SECTION 00 90 01
BIDDING AND CONTRACT REQUIREMENTS
ADDENDUM NUMBER 1

Issued: May 27, 2025

Re: ADDENDUM NUMBER (1) TO THE BIDDING DOCUMENTS FOR

McHenry County College
Engagement Hall
Architect's Project Number: 24-027

A2.02

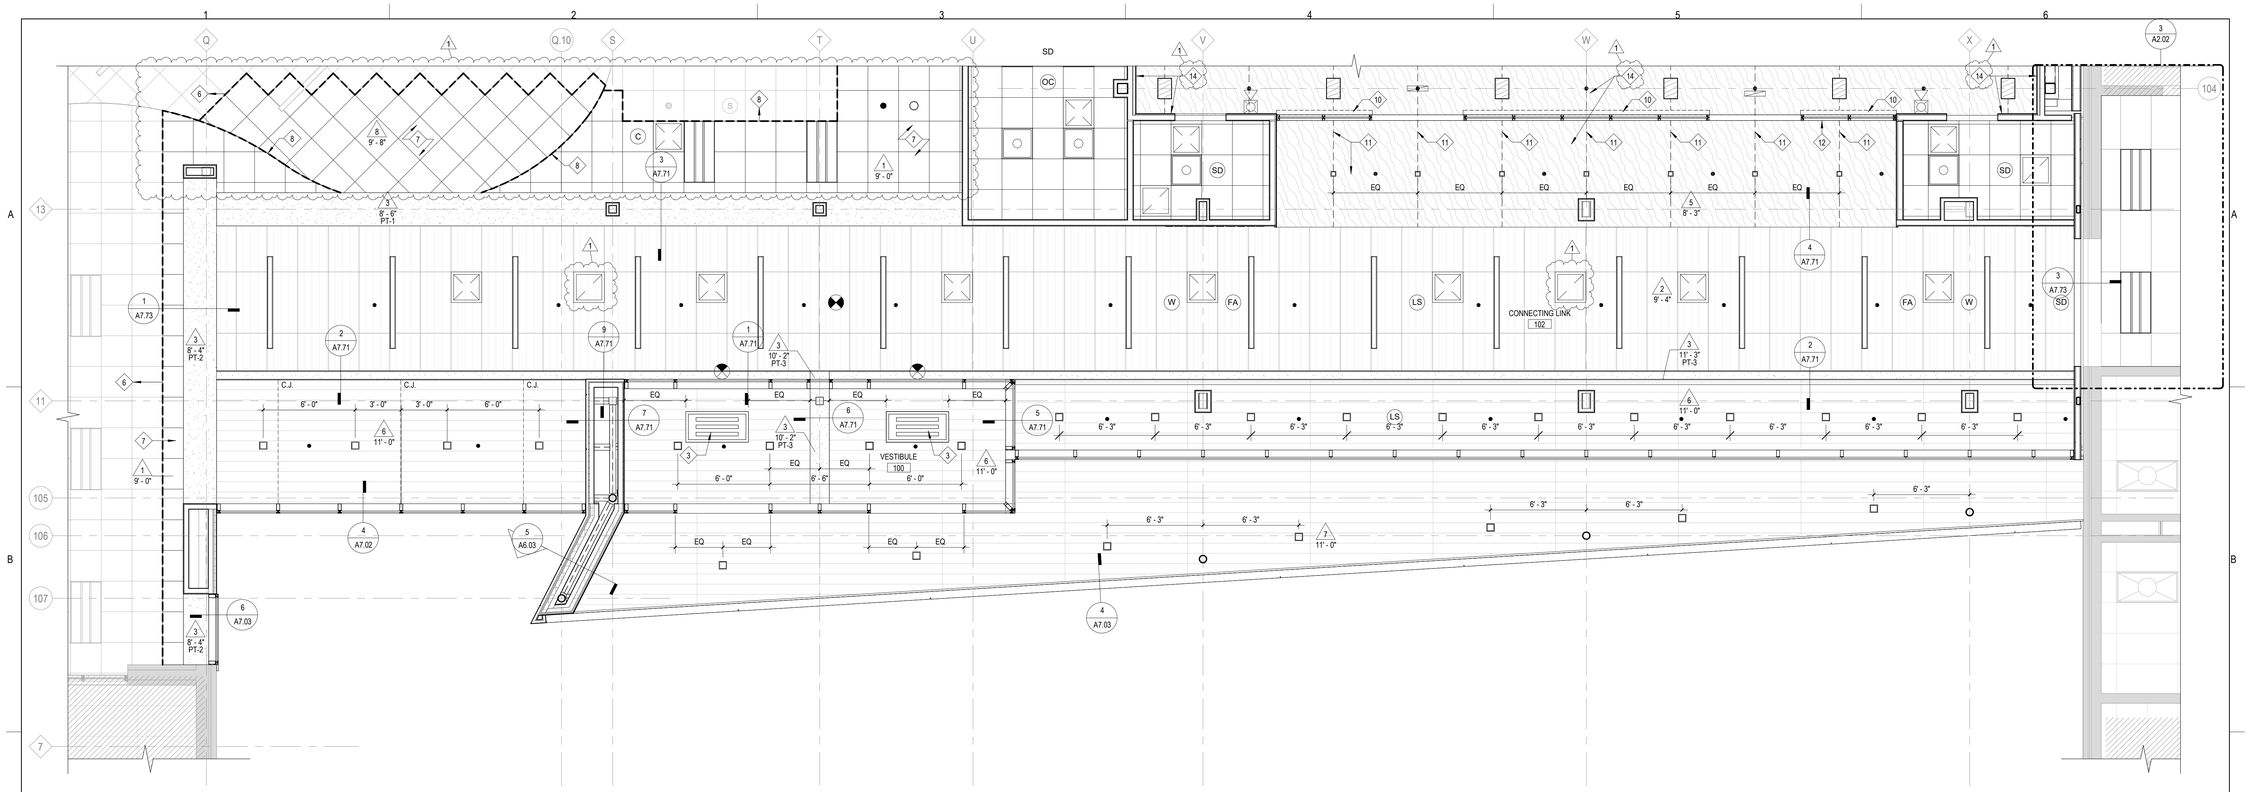
5. A2.02
    A. **REVISE** extent of existing ceiling to be demolished and existing ceiling to remain in dining area.
    B. **REVISE** text note about bid alternate 8 and 9 on RCP to note 14 and note 15 on RCP Referenced Notes.

3 WALL SECTION - ENGAGEMENT HALL - WEST 2
3/4" = 1'-0"

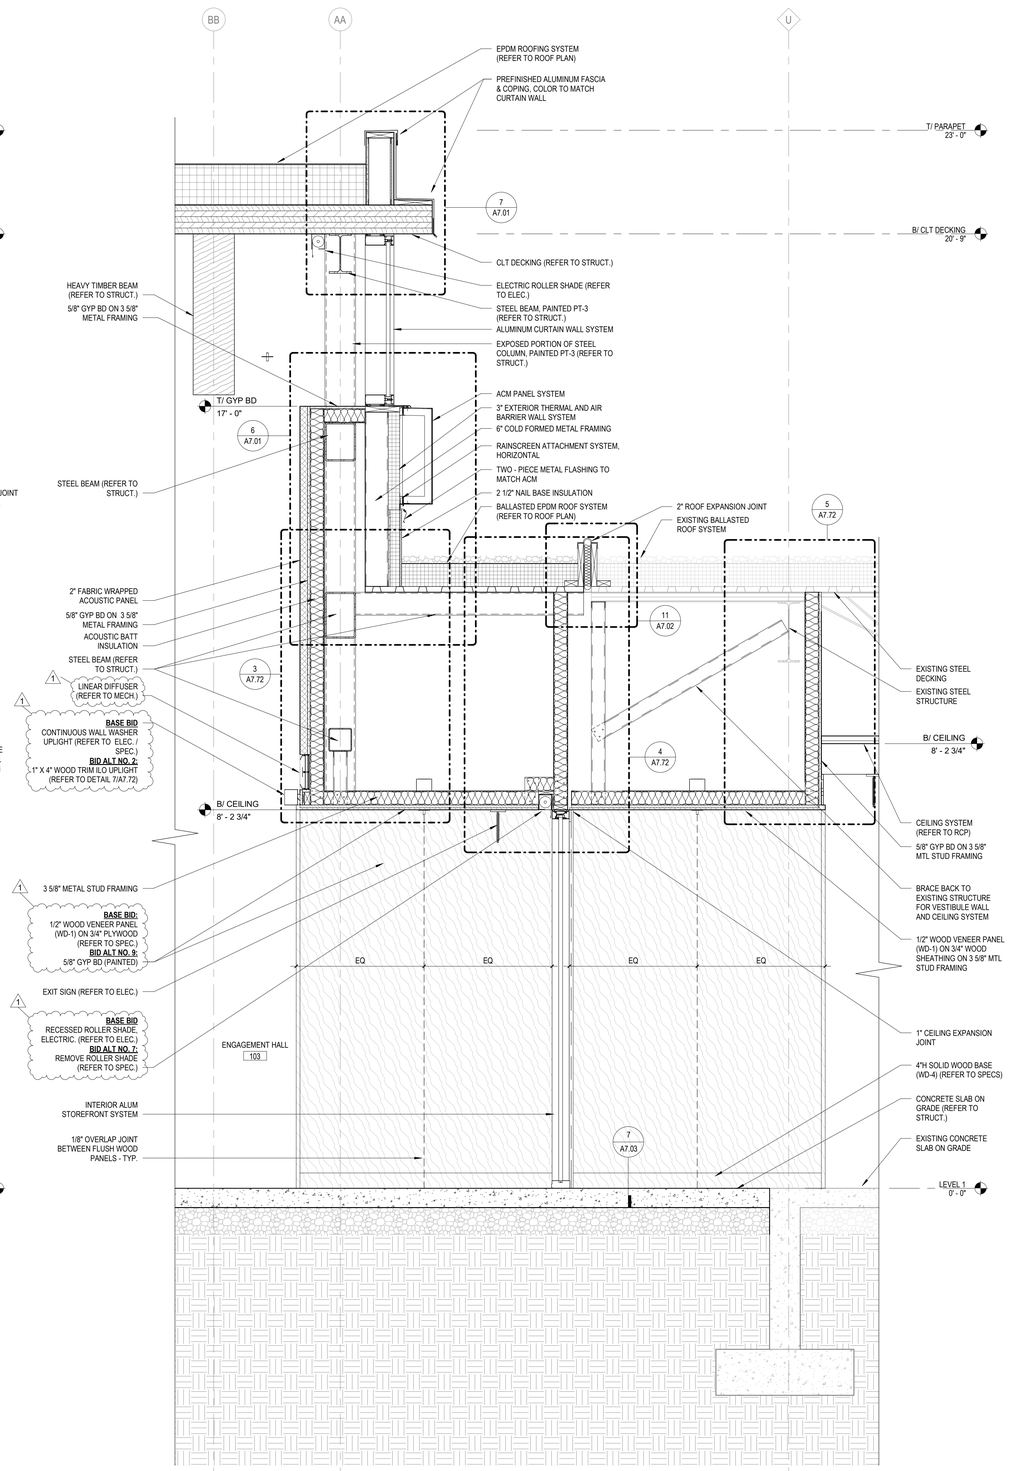
E. **ADD** linear diffuser note to WALL SECTION – ENGAGMENT HALL – WEST 2.
8. A6.03
    A. **REVISE** continuous wall washer uplight base bid and alternate 2 note.

1 WALL SECTION - ENGAGEMENT HALL- EAST
3/4" = 1'-0"

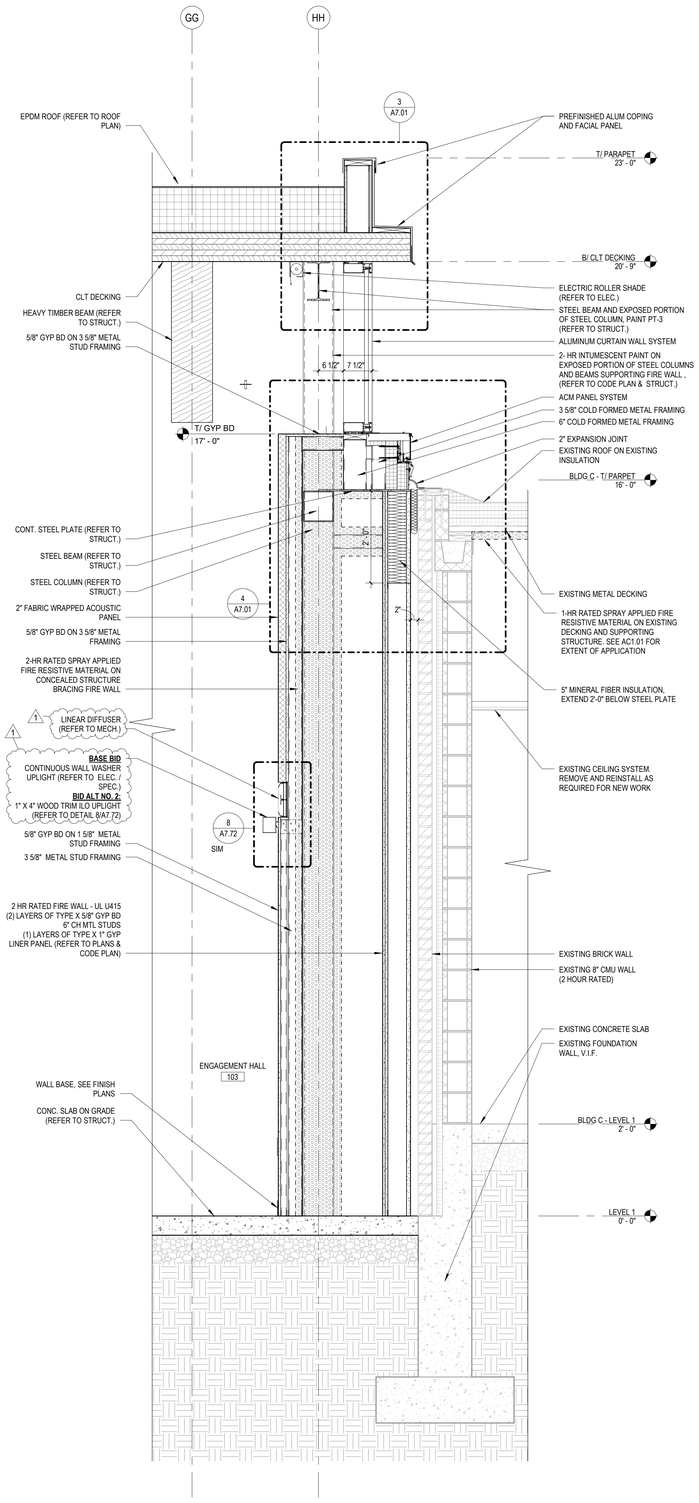
B. **ADD** linear diffuser note to WALL SECTION – ENGAGEMENT HALL – EAST.
9. A6.04
    A. **ADD** exit sign note to WALL SECTION – ENGAGEMENT HALL – SOUTH.

11 SECTION DETAIL - ACM AT EXISTING SOFFIT
1 1/2" = 1'-0"

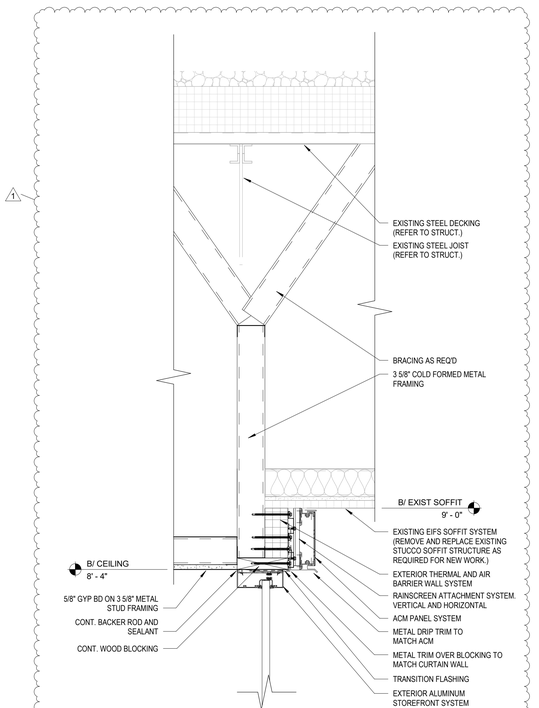
11. A7.03
    A. **ADD** detail 11/A7.03 SECTION DETAIL – ACM AT EXISTING SOFFIT to sheet.
12. A7.51
    A. **ADD** note “OVERFLOW DRAIN (REFER TO PLUMBING)”.

4 CEILING DETAIL - TYPICAL MOUNTING HEIGHTS AT CLT
1" = 1'-0"

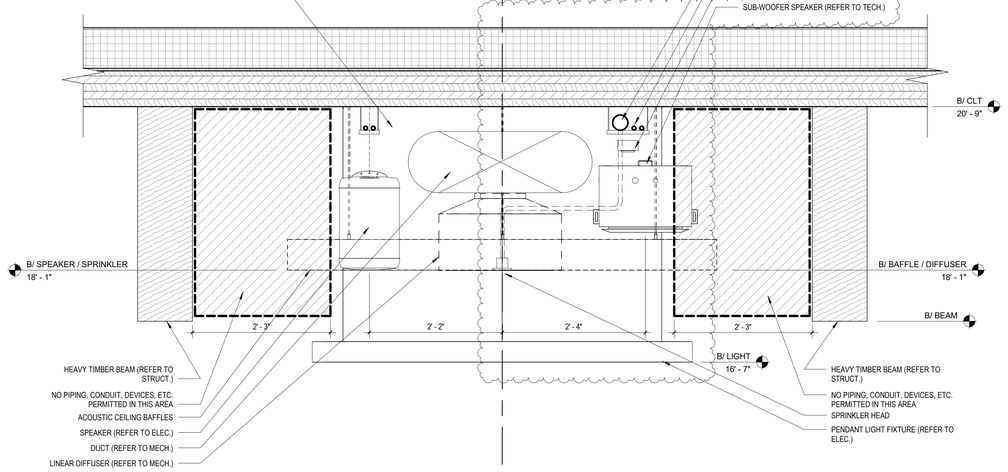
C. **ADD** notes to CEILING DETAIL – DOUBLE EGRESS DOOR HEAD.
    D. **REVISE** CEILING DETAIL – TYPICAL MOUNTING HEIGHTS AT CLT.
    E. **ADD** view 5/A7.73 CEILING DETIAL – TYPICAL MOUNTHING HEIGHTS AT CLT – NO DUCTWORK.

SHEET NUMBER:
A11.01

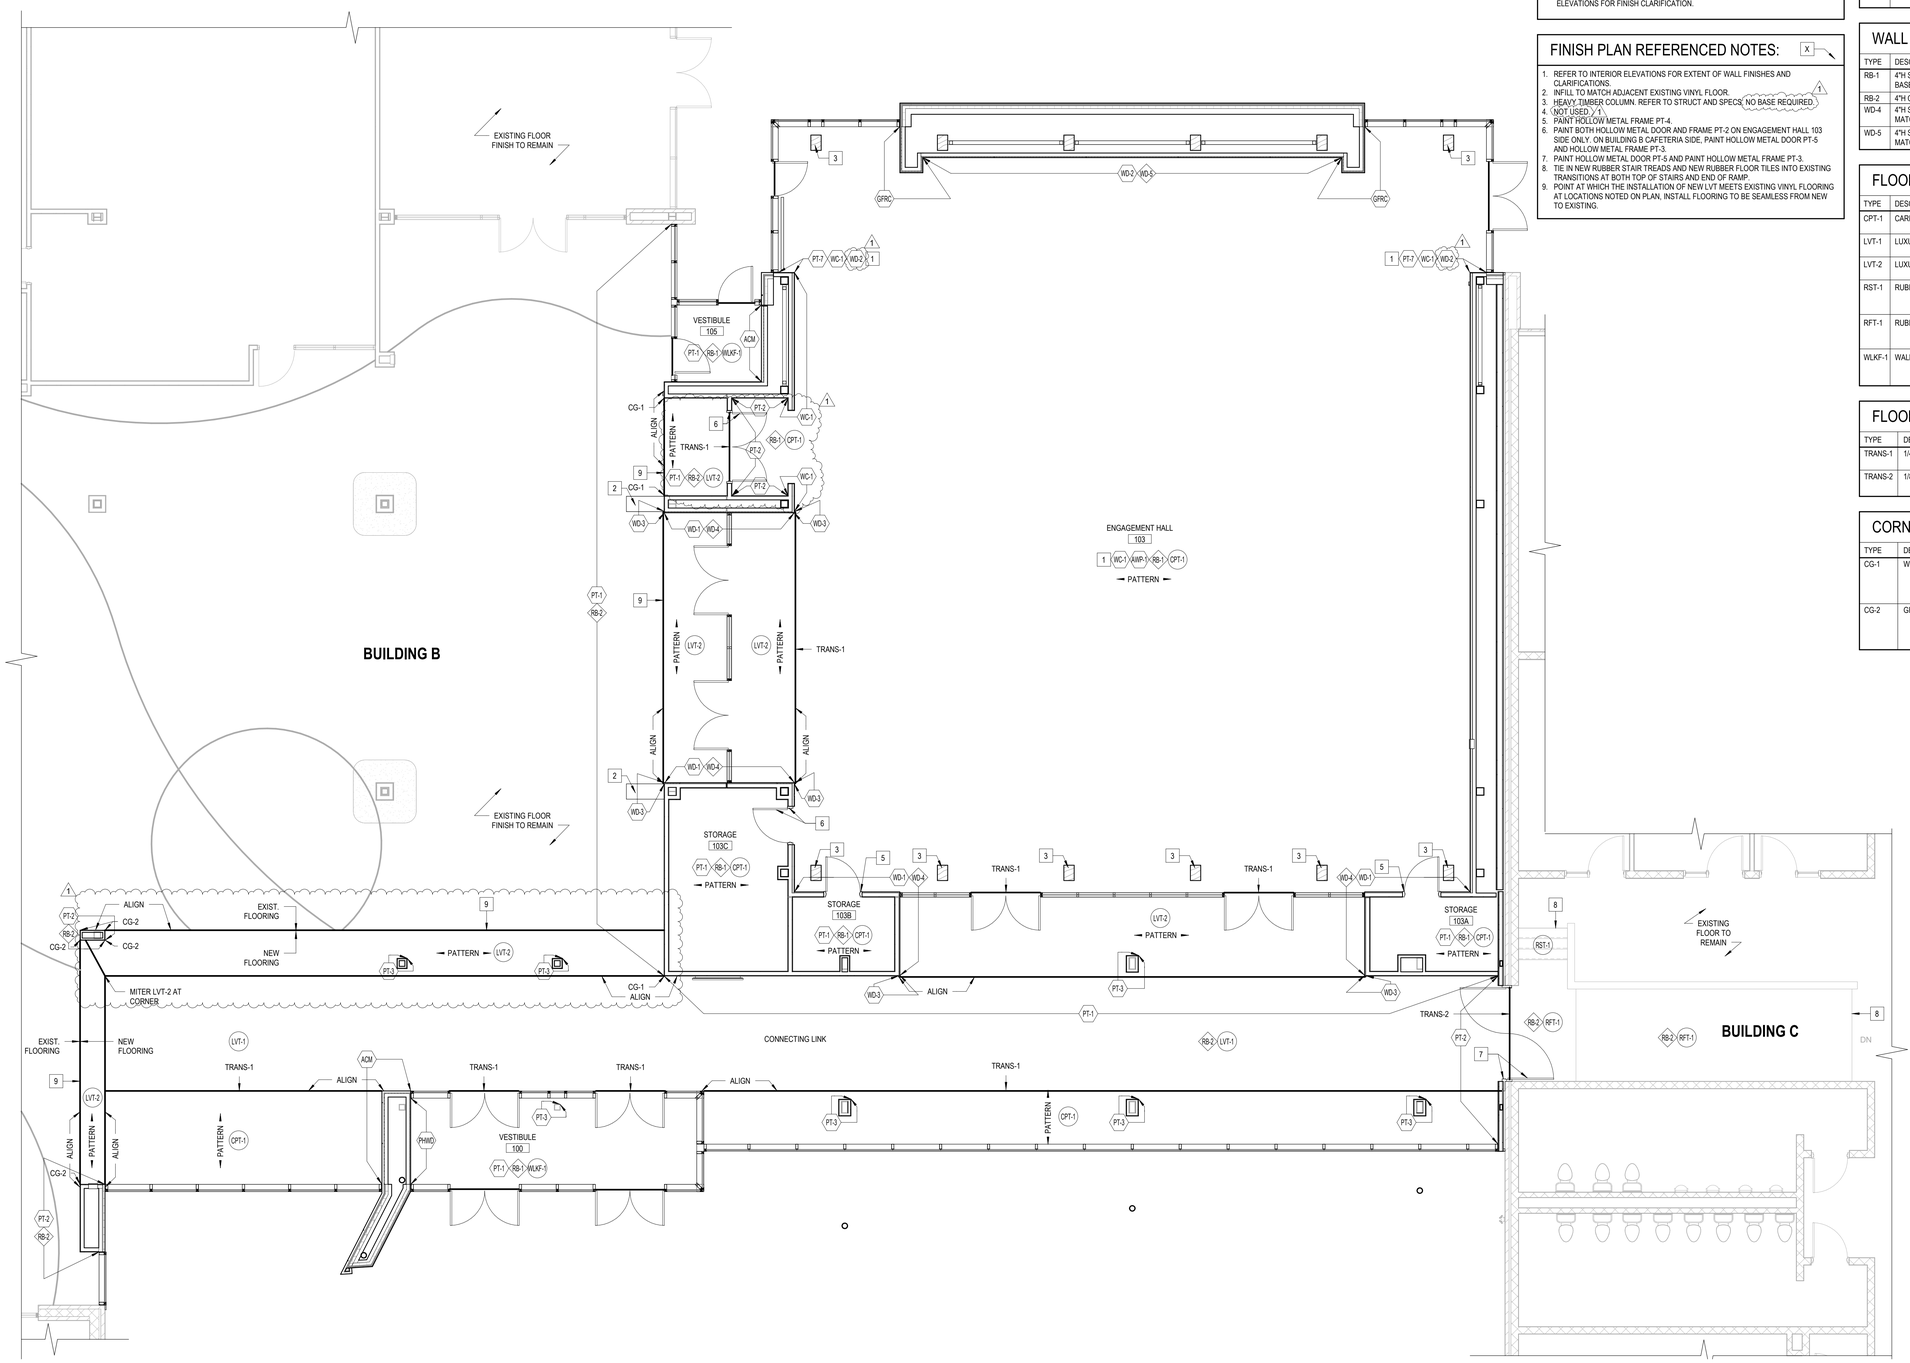
20. A11.01
    A. **REVISE** Finish Plan General Note #9 to say ENGAGEMENT HALL 103.
    B. **REVISE** PT-5 paint color to Sherwin Williams – Dovetail 7018.

SHEET NUMBER:
AD2.01

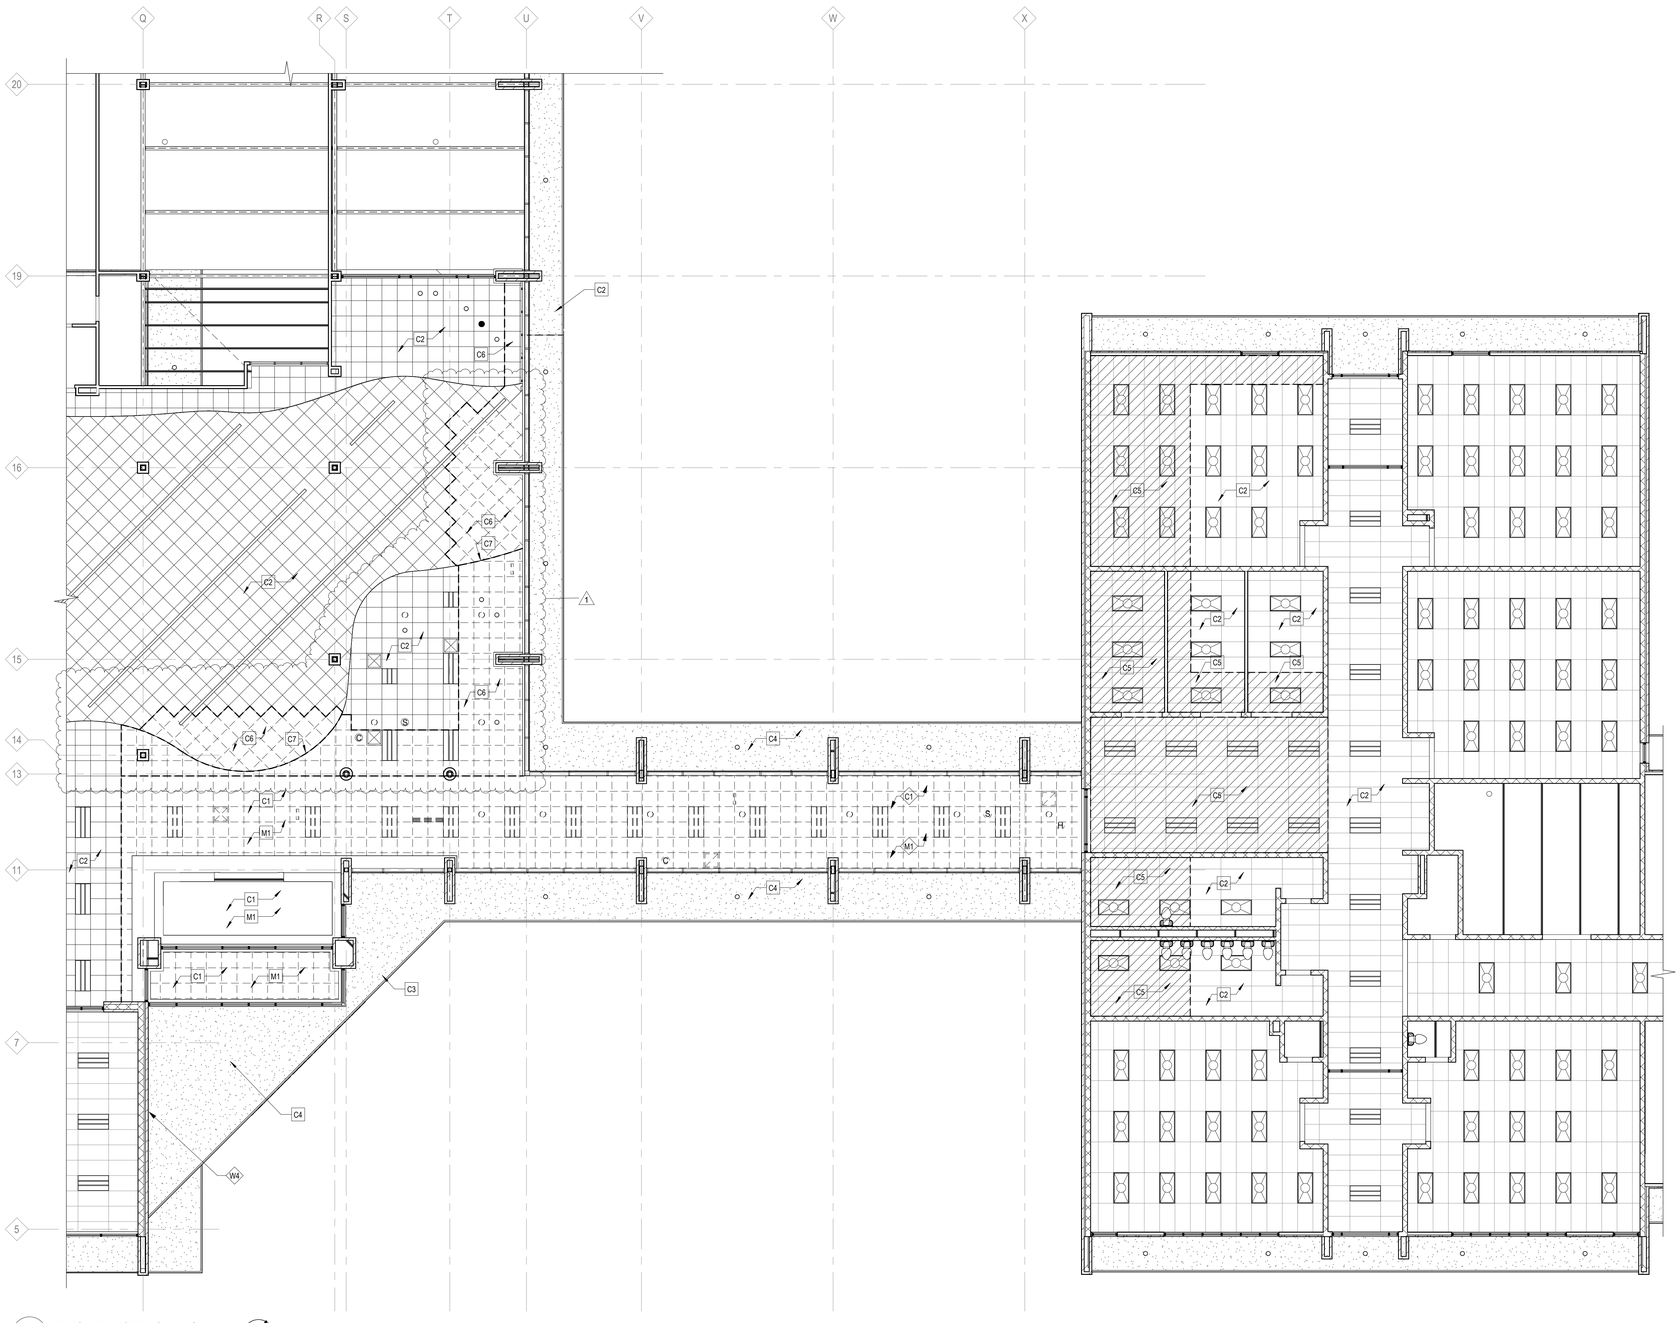
ARCHITECTURAL
1. AD2.01
    A. **REVISE** extent of existing ceiling demolition.
